From: LUNCO Front Desk [frontdesk@mlundygroup.com]
Sent: Monday, December 17, 2012 2:35 PM
To: Nichols, Andrew; Mix, Kenneth; Wood, Justin
Cc: 'Steve Olmstead'
Subject: RE: Parkside
Attachments: Tabled 491 Eastern Blvd - Site Plan.pdf

I am writing in response to the October 29th Memorandum in regard to Parkside Bible Church. Below I have addressed each item of the Summary.

New Expansion Project Parkside Bible Church

ISSUE DATE: 12/17/12 (Rev.-4)

DRAWING NO.
C101
 SITE LAYOUT PLAN

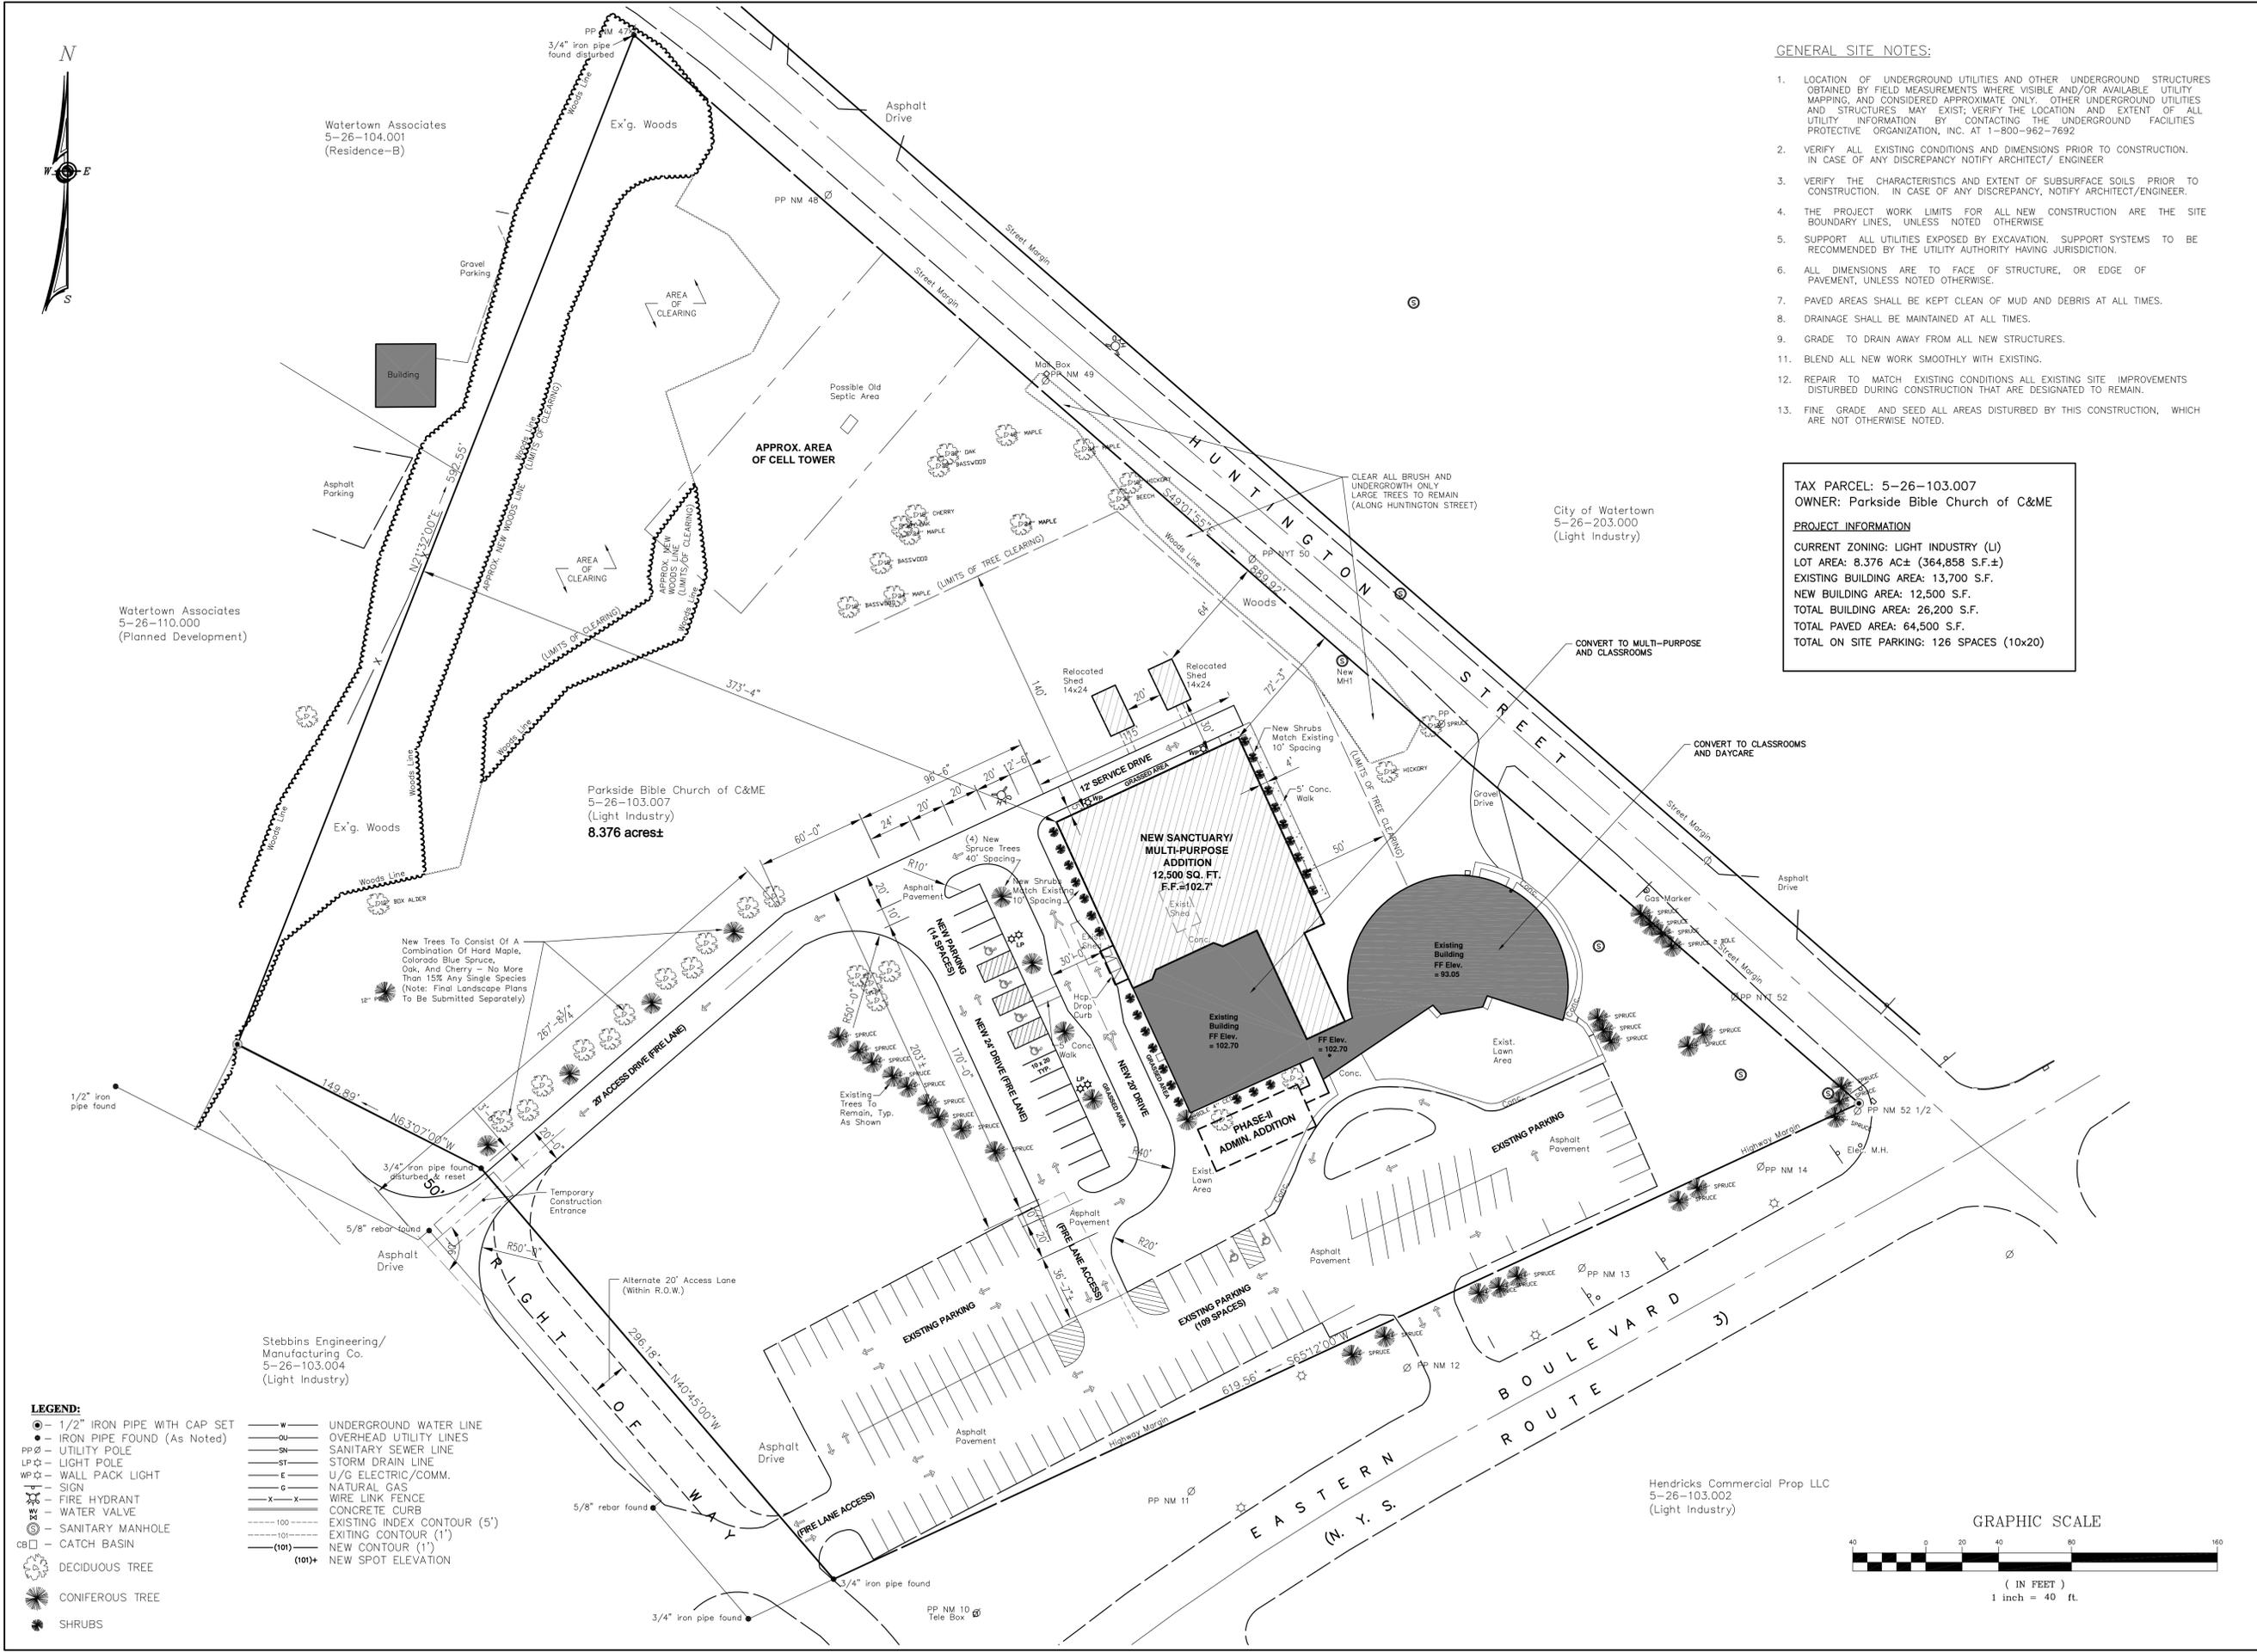
8. Parkside Bible Church disagrees with the Planning Board's recommendation of additional landscaping. The building perimeter shall be landscaped in a manner consistent with the existing. However, no additional tree are desired around the parking lots or in front of the building. The rear of the building will be an open lawn area for outdoor functions and no trees are desired.

REVISIONS		
DATE	DESCRIPTION	BY
10/18/12	REVISION NO.-2	W.J.L.
10/24/12	REVISION NO.-3	W.J.L.
12/17/12	REVISION NO.-4 REVISED PLANTINGS AND TREE CLEARING ALT. ACCESS LANE	W.J.L.

**SITE LIGHTING
AND UTILITY PLAN**

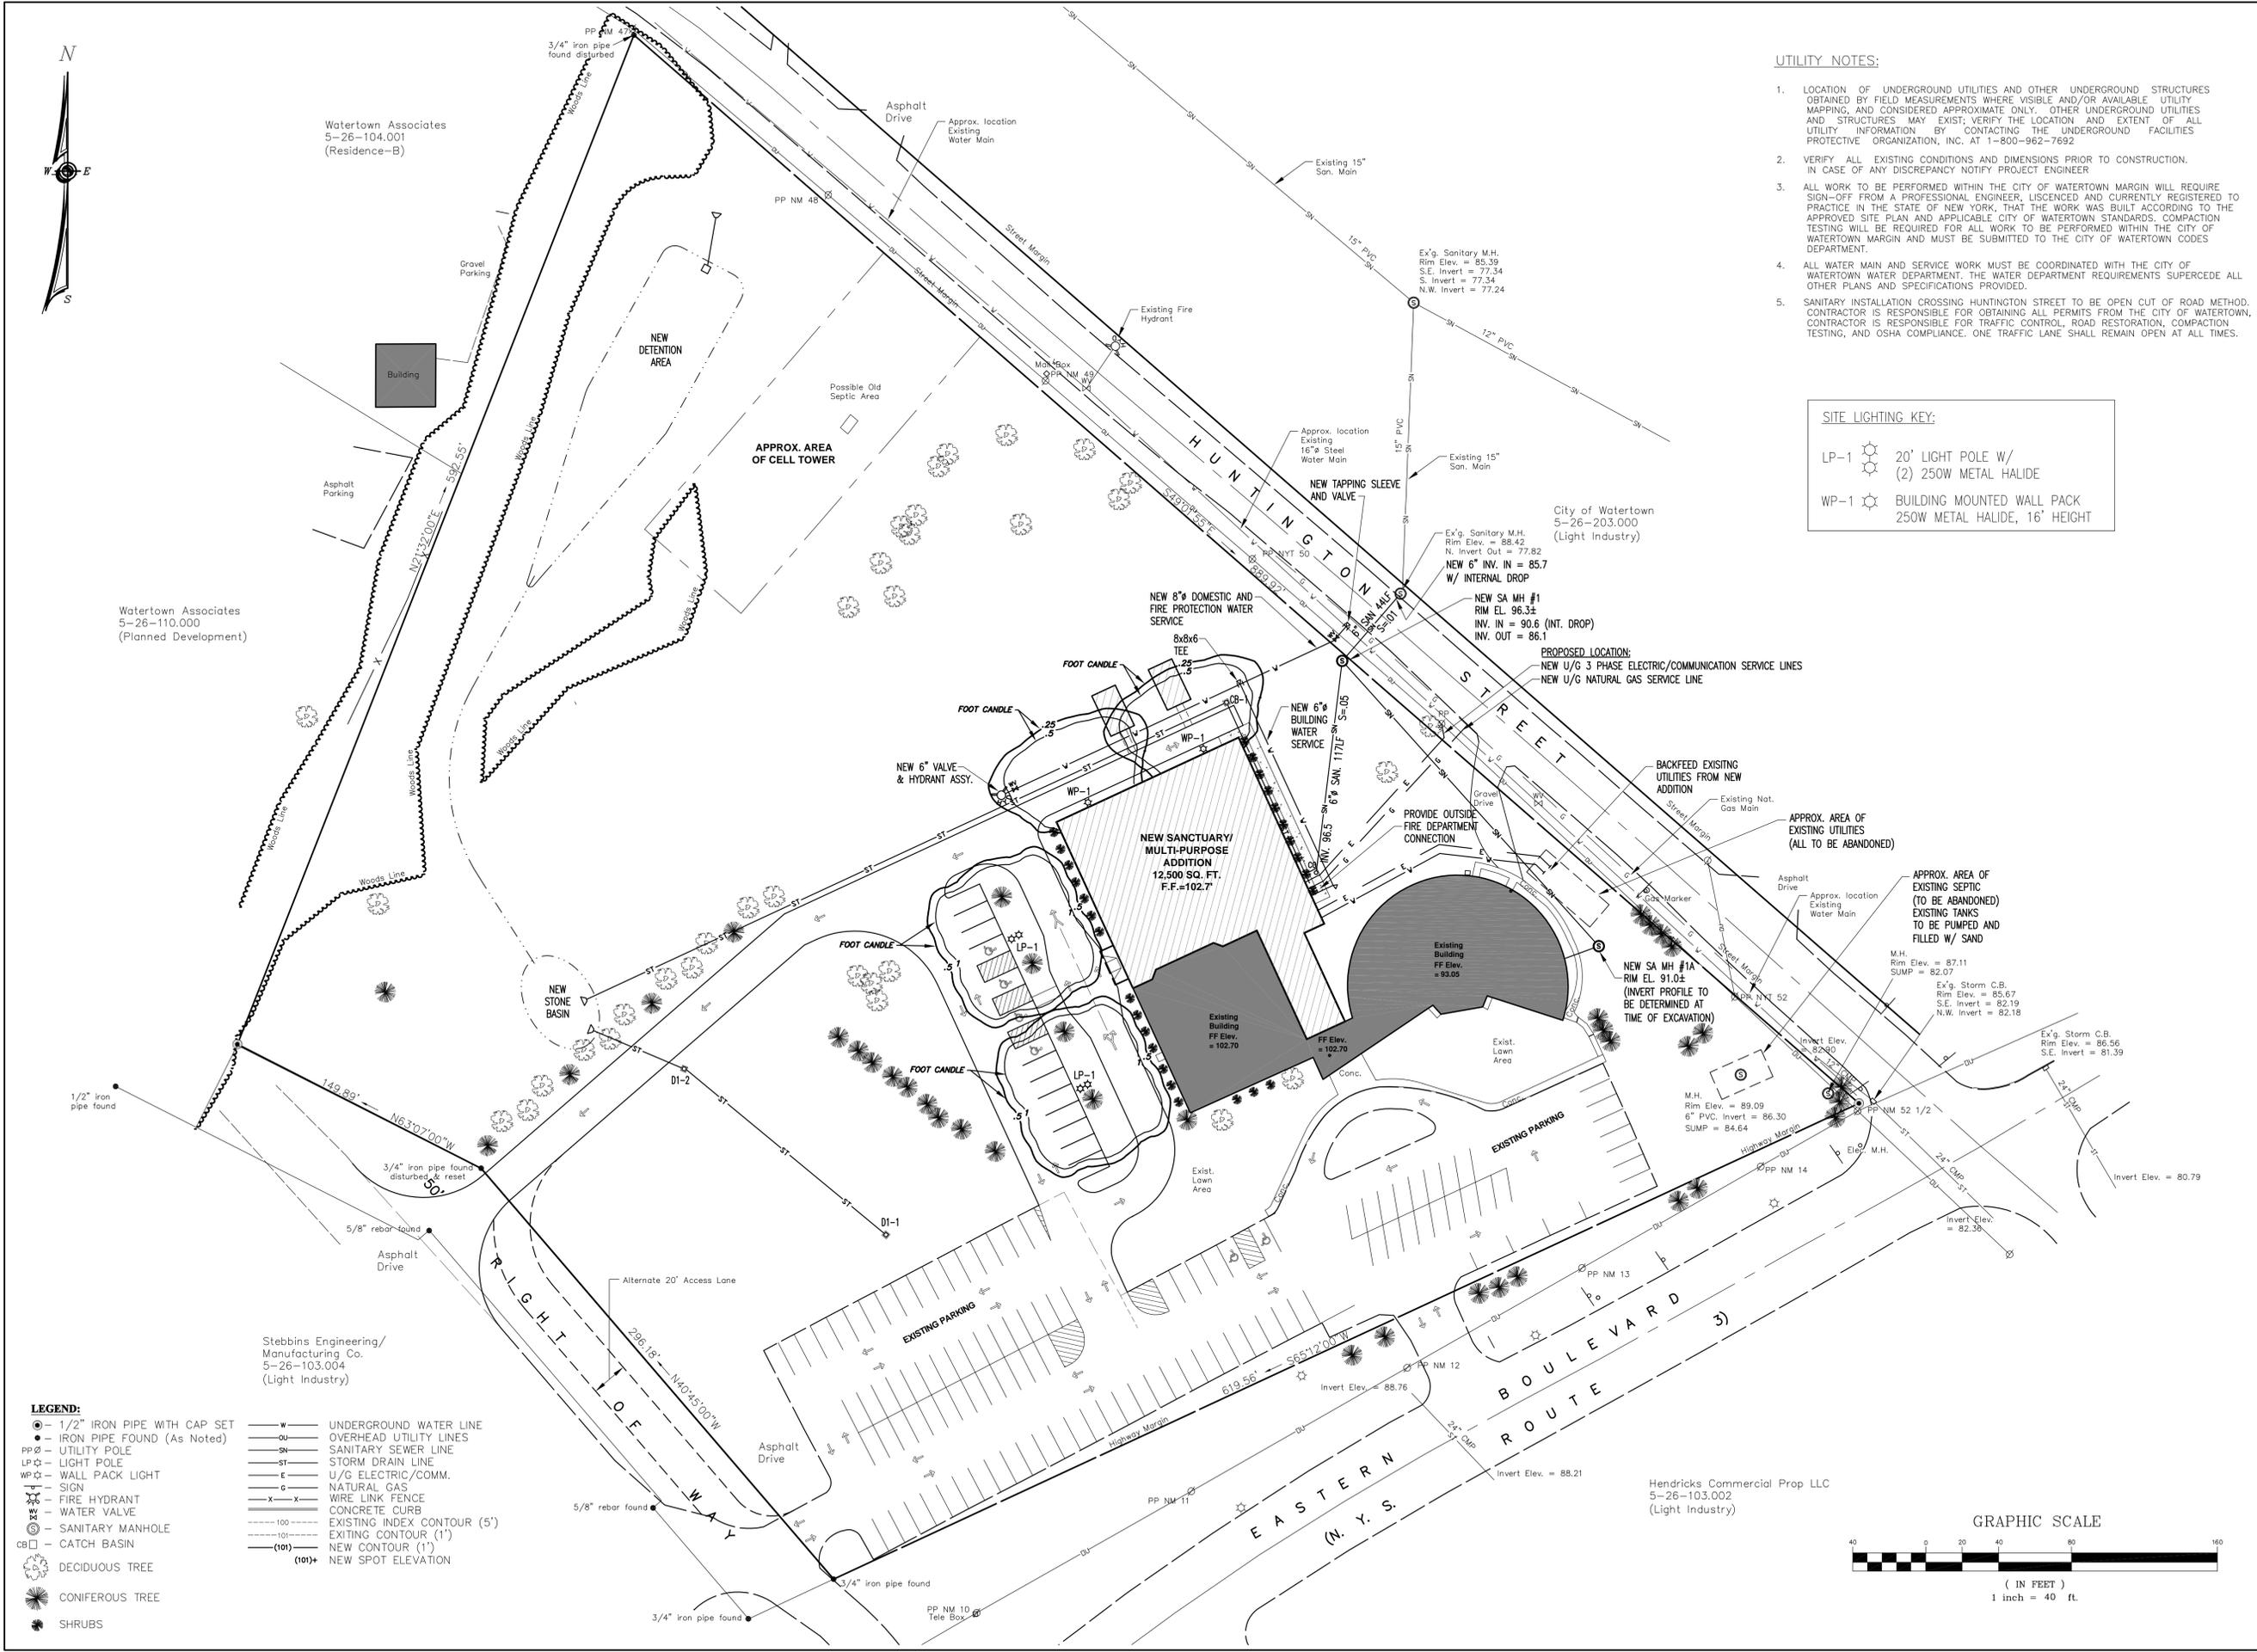
3. The new fire hydrant shall be shown at the southwest corner of the structure with the appropriate reconfiguration of water line and valves.
4. See Item 3

DATE	DESCRIPTION	BY
09/17/12	REVISED NEW SANITARY INVERTS	WJL
10/18/12	REVISION NO.-2	WJL
10/24/12	REVISION NO.-3	WJL
12/17/12	REVISION NO.-4 REVISED WATER LINE/ FIRE HYDRANT	WJL
